**SUNDRY NOTICES AND REPORTS ON WELLS NMOC D ARTESIA**  
*Do not use this form for proposals to drill or to re-enter an abandoned well. Use form 3160-3 (APD) for such proposals.*

OCHO CINCO FED COM 001H

30-015-37614

**Permanent Abandonment of Federal Wells  
Conditions of Approval**

Company: COG Operating LLC  
Well Name: Ocho Cinco Fed Com #1H  
API #: 30-015-37614  
Spud Date: 3/1/2010

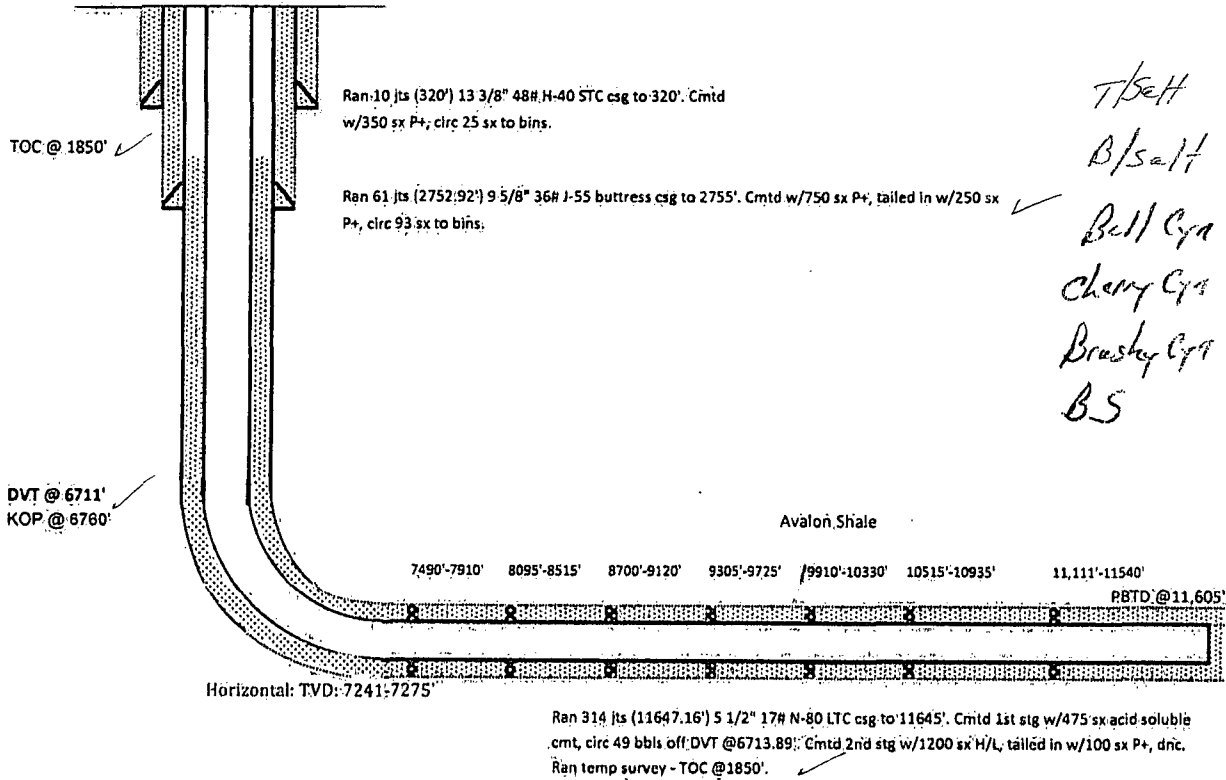
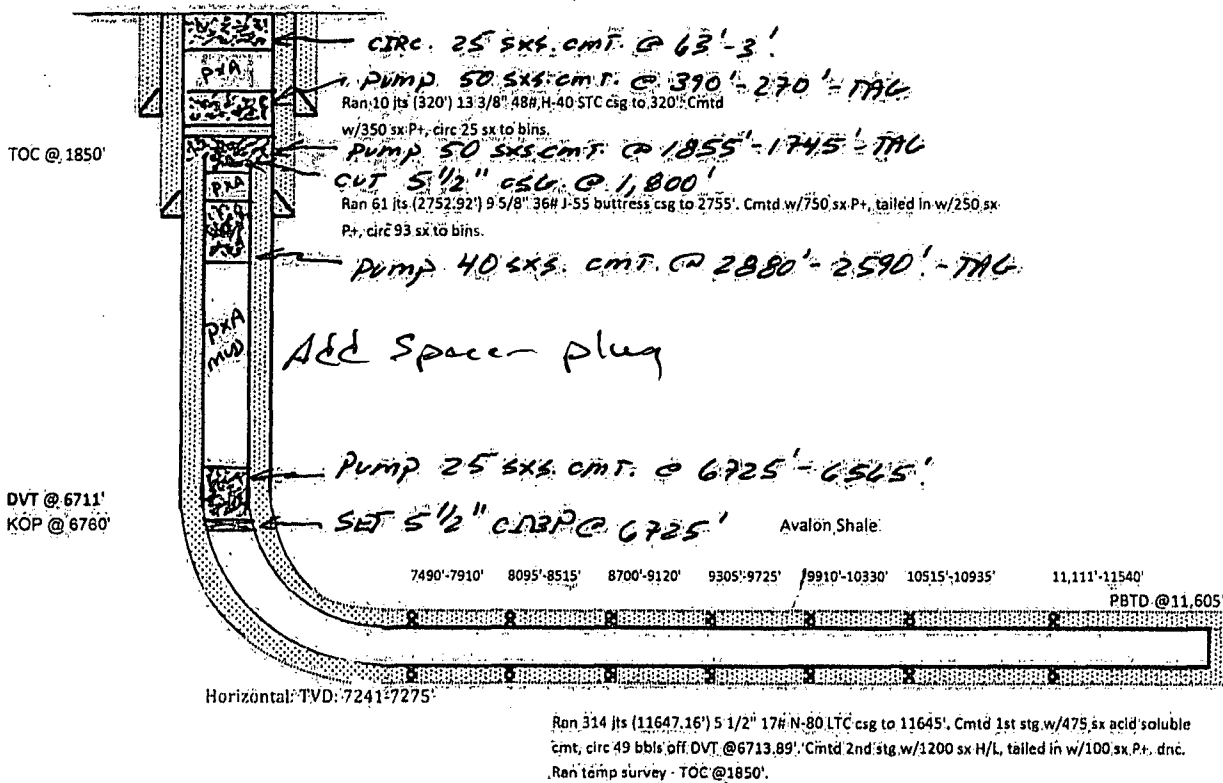
- 1) SET 5-1/2" CIBP @ 6,725'; PUMP 25 SXS.CMT. @ 6,725'-6,565'(DV TOOL).
- 2) CIRC. WELL W/ PXA FLUID. *X Add Spacer Plug from 4500' - 4360'*
- 3) PUMP 40 SXS.CMT. @ ~~2,880'~~ 2,500' T/DLWR., 9-5/8" CSG. SHOE, B/SALT); WOC X TAG. *2914' - 2622'*
- 4) CUT X PULL 5-1/2" CSG. @ +/-1,800'.
- 5) PUMP 50 SXS.CMT. @ 1,855'-1,745'(5-1/2" CSG. STUB); WOC X TAG.
- 6) PUMP 50 SXS.CMT. @ ~~890'~~ 270'(13-3/8" CSG. SHOE, T/SALT); WOC X TAG CMT. PLUG. *560' - 270'*
- 7) MIX X CIRC. TO SURF. 25 SXS.CMT. @ 63'-3'.
- 8) DIG OUT X CUT OFF WELLHEAD 3' B.G.L.; WELD ON STEEL PLATE TO CSGS. X INSTALL DRY HOLE MARKER.
